Response to Submissions Report Central Barangaroo Concept Plan MP06_0162 Modification 9

RESPONSE TO SUBMISSION REPORT

This Response to Submissions Report (**Submissions Report**) has been prepared by Mecone Group (**Mecone**) on behalf of Infrastructure NSW (the **Applicant**) in support of a request to modify the Barangaroo Concept Plan (**MP06_0162**). This Submission Report relates to MP06_0162 MOD 9 (the **project**).

FIGURE 6 – EXHIBITED BUILDING ENVELOPE LEFT AND AMENDED ENVELOPE RIGHT (SJB)

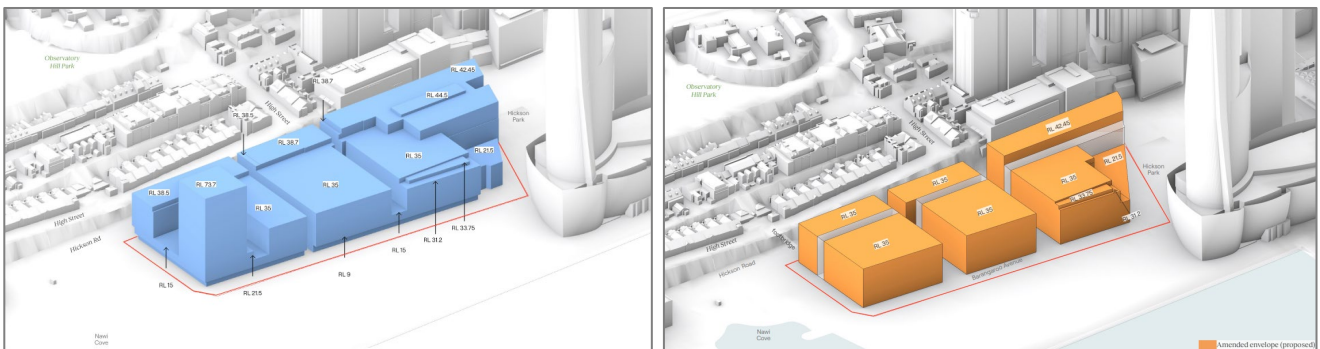
The height and massing of the building envelopes have been scaled back significantly following exhibition. This includes the removal of the previously proposed tower element on Block 7.

The proposed heights for Block 7 have been amended from RL 73.7 to RL 35 and represents a decrease of 38.7 metres and is now less than half the height that was originally proposed. This reverts the proposed heights for Block 7 back to its original state under the approved Concept Plan and provides a built form transition to Nawi Cove, Headland Park and the Millers Point Heritage Conservation Area.

The proposed heights for Block 5 have been amended from RL 44.5 to RL 42.45, RL 35, RL 33.75, RL 31.2 and RL 21.5, which represents a decrease of 2.05 metres. Block 5 represents the tallest building component for MOD 9 and is located in the southeastern portion of the site where it directly interfaces with taller buildings in Barangaroo South. The predominant height of Block 5 is RL 35, which is generally consistent with the approved Concept Plan heights and also includes a lower RL 21.5 building envelope that directly interfaces with Hickson Park.

FIGURE 25 – EXHIBITED BUILDING ENVELOPE LEFT AND AMENDED ENVELOPE RIGHT (SJB)

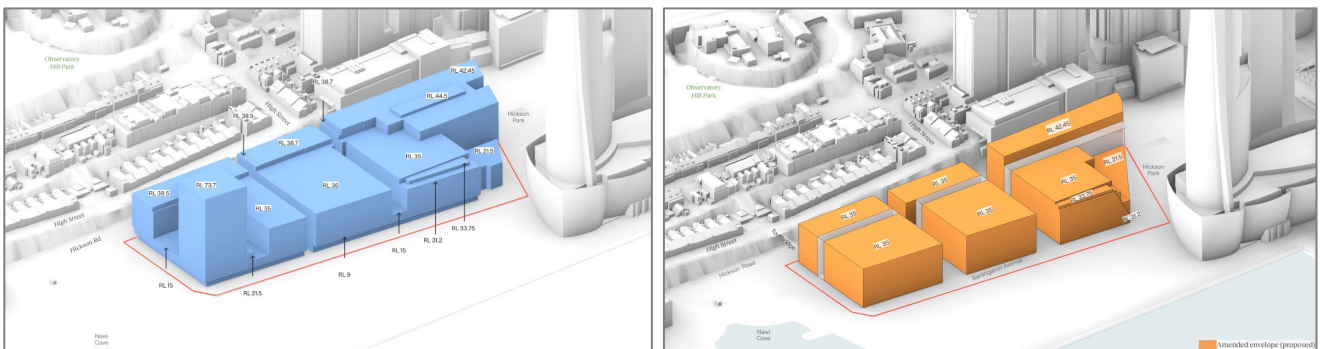
Overall, the amended proposal introduces a simplified building envelope at a reduced scale, including a reduction in the proposed GFA, additional public domain offering and the deletion of the previously proposed tower element located at Block 7. Refer to **FIGURE 25**.

The exhibited MOD 9 application proposed a GFA of 144,355m² for Blocks 5, 6 and 7 (above and below ground). The amended MOD 9 application reduces this by 40,355m², resulting in a revised GFA of 104,000m² (above and below ground).

FIGURE 28 – AMENDED CONCEPT BUILDING ENVELOPE WITH EXHIBITED CONCEPT BUILDING ENVELOPE (SJB)

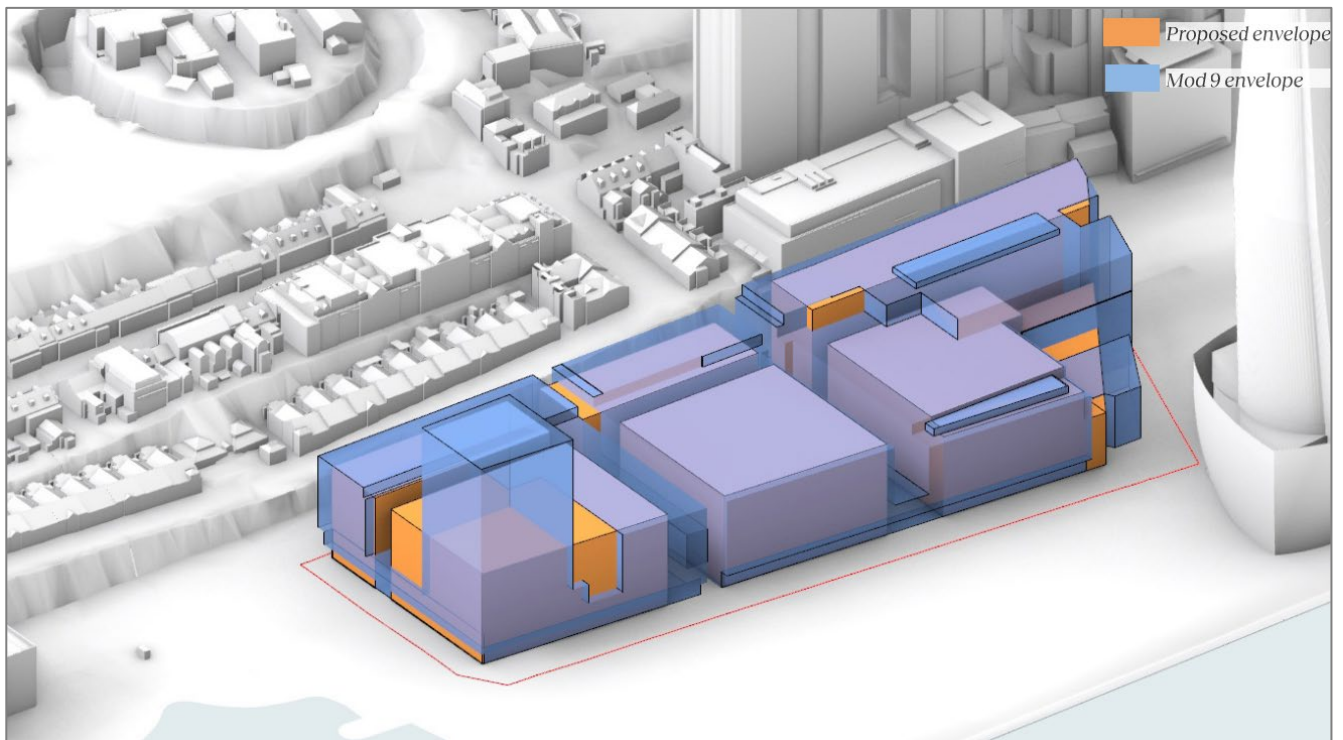
FIGURE 28 depicts the amended building envelope overlaid with the exhibited building envelope.

FIGURE 41 – PRINCIPLES FOR HICKSON PARK (SJB)

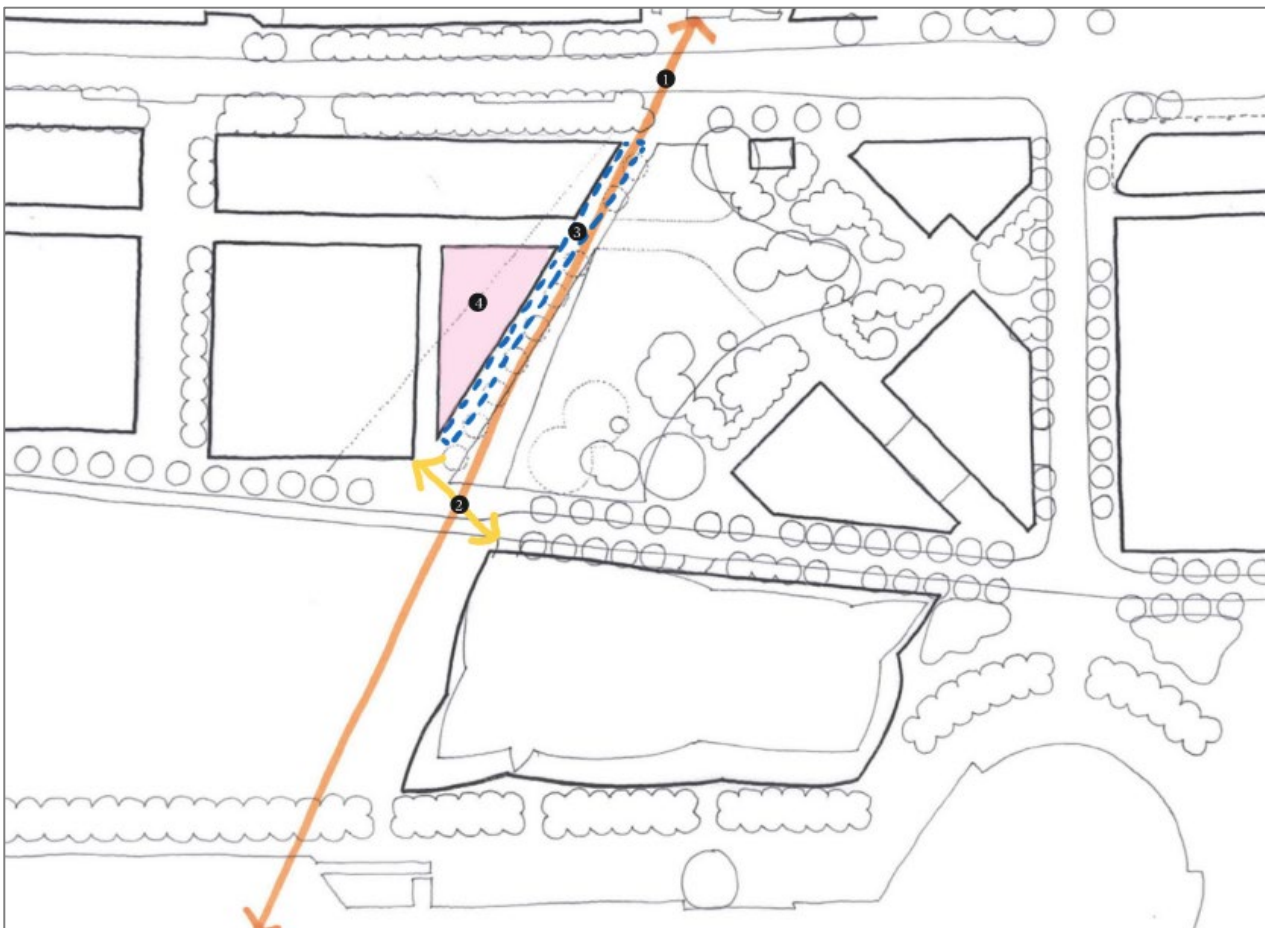
Within the site, Hickson Park will be reduced by 1625m². As a whole, the size of Hickson Park has been reduced from 11,414m² under the current Concept Plan to 9,789m², as shown in **FIGURE 41**. The Hickson Park and Block 5 alignment has been amended to deliver the following outcomes:

It is proposed to amend Condition B3 to reflect the revised alignment of Hickson Park. Specifically, the area of Hickson Park that can be overshadowed between 12pm and 2pm mid-winter has been reduced from 3,300m² (as exhibited) to 3,000m² (as amended).

FIGURE 51 – PROPOSED ENVELOPE AMENDMENTS (SJB)

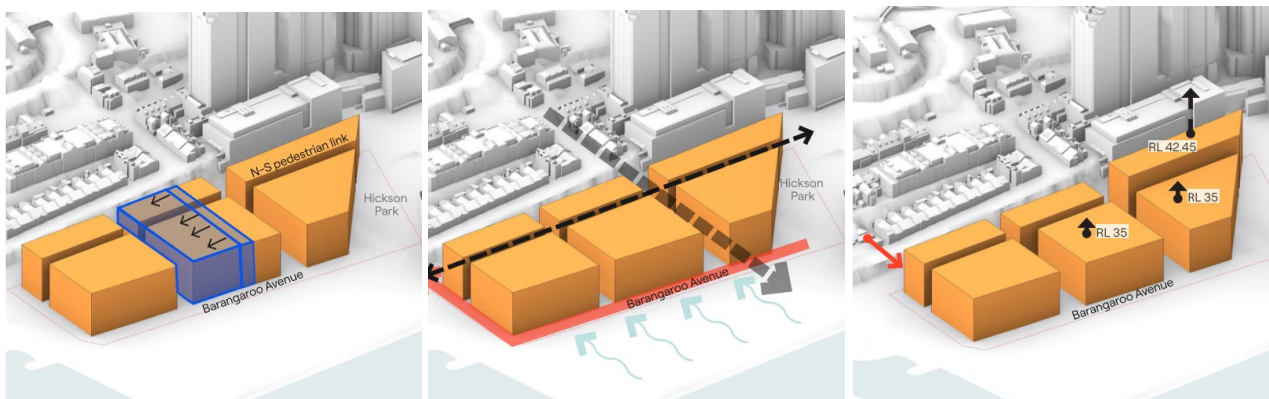
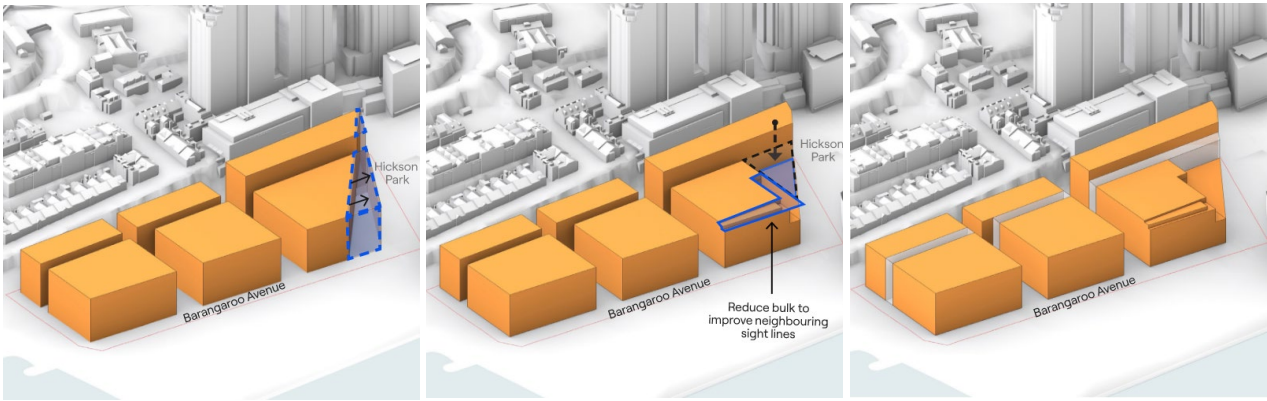
As described in previous sections of this Submissions Report, the design has undergone major refinement following exhibition and is underpinned by a revised urban design strategy and building envelopes. These design strategies are summarised in **FIGURE 51** and include:

- Maintain High Street, extend Scotch Row via a north-south pedestrian link and extend Barangaroo Avenue around the site,
- Rebalance development parcels and public interface with the water by widening the northern east-west link and increase view corridors to the harbour,
- Reinstate historic footbridge link to the northern end of Block 7
- Increase height in zones to the southeastern corner of Block 5 without adverse impact,
- Adjust southern edge of Block 5 to obtain consistent block structure, and
- Reduce block height to respond to Hickson Park.

FIGURE 55 – PROPOSED CONCEPT PLAN BUILDING ENVELOPE SOLAR ANALYSIS

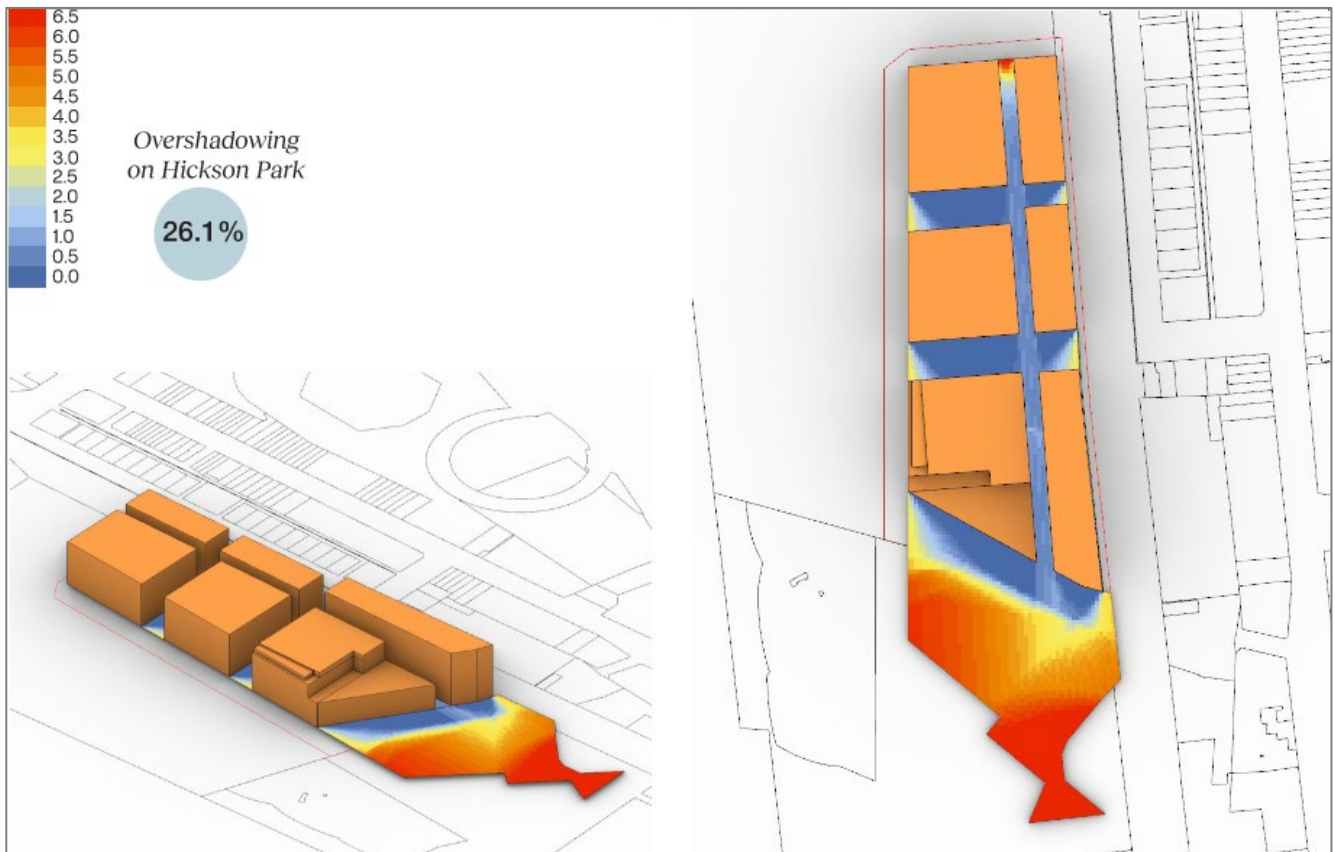
the approved Concept Plan building envelope by 1,275m². This is achieved in part by lowering the Block 5 southern building envelope to RL 21.5 and RL 31.2. Refer to **FIGURE 55**.

Overall, the solar performance of Hickson Park is not significantly impacted despite the alterations to its size. Furthermore, the amended MOD 9 proposal provides an overall increase in open space and public domain across the site as an offset to the alignment at this location.

FIGURE 57 – WIND ANALYSIS OF APPROVED CONCEPT PLAN AND PROPOSED CONCEPT PLAN (RWDI)

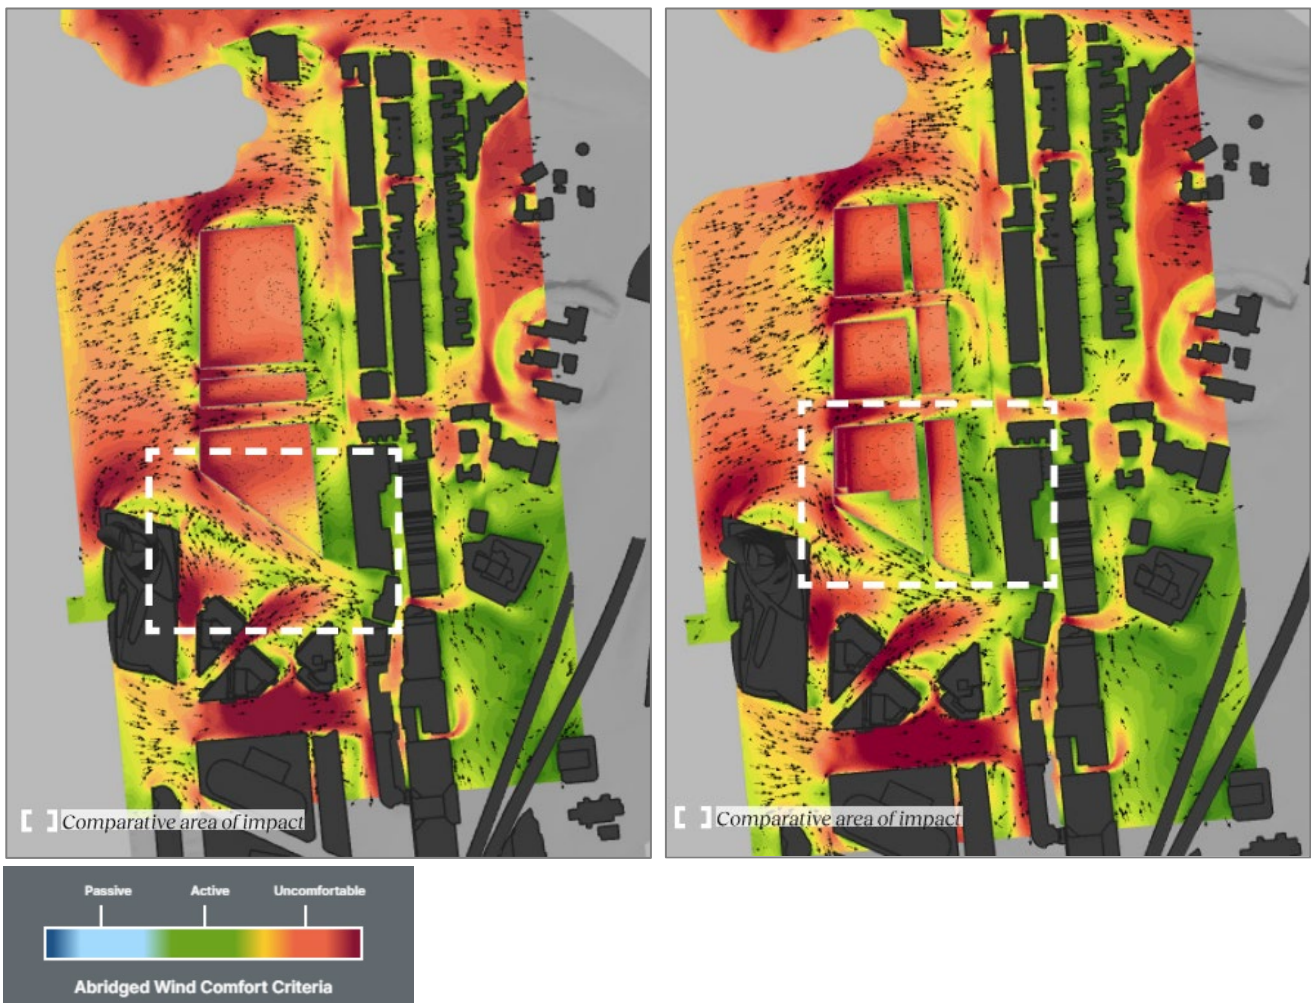
The amendments to the building envelope demonstrate a decrease wind washing effects along the southern edge and provides a greater level of pedestrian comfort. This is achieved by slightly reducing the aperture/opening of the south western corner of Block 5 and is depicted in **FIGURE 57**.

The amended building envelope also provides greater areas for pedestrian comfort in the public domain by proposing the north-south pedestrian link, which will be protected by westerly winds.
